Engineers Comments Regarding Surface Water Drainage

Application Reference:	Y/45/25/DOC	Reviewer Reference:	ADC/EXT4
Planning Officer:	Simon Davis	Date of Review:	14/11/2025
Site Name:	Land at Stakers Farm North End Road Yapton		
Application Description:	Approval of details reserved by condition imposed under reference Y/44/17/OUT relating to condition number 17 - SuDS .		
Assessment Number:	2 of 2

Application Reference: Y/45/25/DOC (Y/19/25/DOC) Site Name: Land at Stakers Farm North End Road Yapton	Initial Issue Date: 14/11/2025 Issue Date: 14/11/2025 Reviewer Reference: ADC/EXT4
---	---

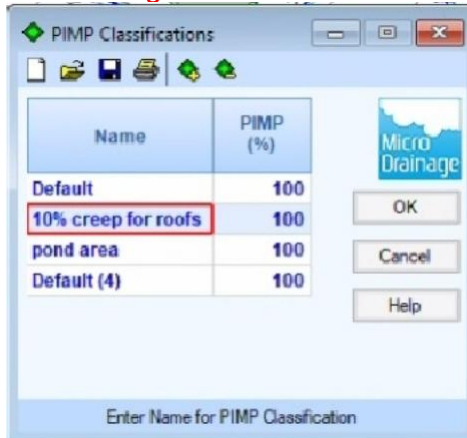
observations (Doc ref: 'As Built 70 Units SW Network'): - Some of the nodes in the 1st sheet of 'As Built 70Units SW Network' are missing in the Microdrainage calculations (i.e....ICs S38, S39, S40 etc). Please make sure that all relevant nodes are included in the Microdrainage Calculations; - Some of the pipe gradients shown in the 1st sheet of 'As Built 70units Network' do not match with those shown on the Microdrainage calculations (i.e....Pipe S1.006, S1.007, S1.008, S1.009 etc). Please make sure that all pipe gradients shown on the as-built plan and Microdrainage calculations match; - Please confirm if Urban Creep has been allowed for in the as-built Microdrainage calculations. If yes please demonstrate how this has been taken into account; - Please confirm that Requirement 13 of ADC's Surface Water Drainage Proposals Checklist	model. Rodding eyes and individual connections have not been added to the model as their impact is negligible. Pipe gradients have been amended with the model to match the as built information. There are small rounding differences as the Microdrainage model calculates the pipe to the centre of the manhole instead of the connection point. The pipe gradients may cause confusion as the as built drawing shows the originally designed levels as well. Please refer to the dark blue text for the as built information that will match the Microdrainage model. A 10 percent allowance has been included for urban creep, please see the screenshot below from the Microdrainage model.

(Version 5.2) is met and provide evidence in support of this. The Microdrainage calculations provided indicate that the water level for 1 in 10years + CC storms is above the lowest incoming pipe of the infiltration blanket;

- Please confirm which Safety Factor has been applied from Clause f of ADC's Surface Water Drainage Proposals Checklist (Version 5.2) and demonstrate how this has been applied on the drainage calculations. Is there a risk of flooding developments to the north of the site?;
- Please provide half drain times for the 1 in 10y + CC and 1 in 100y + CC storms;
- Please provide a copy of the soakage tests (BRE Digest 365) confirming existing ground infiltration rates – accepted by LPA at Planning Stage;
- Please provide groundwater monitoring data showing depth of groundwater – accepted by LPA at

A factor of safety of 6.5 has been applied to the Microdrainage model in line with the “Factor of Safety Table” found within the Arun surface water drainage proposal checklist.

Soakage tests have been included in this pack.

Groundwater monitoring data has now been included in this pack.
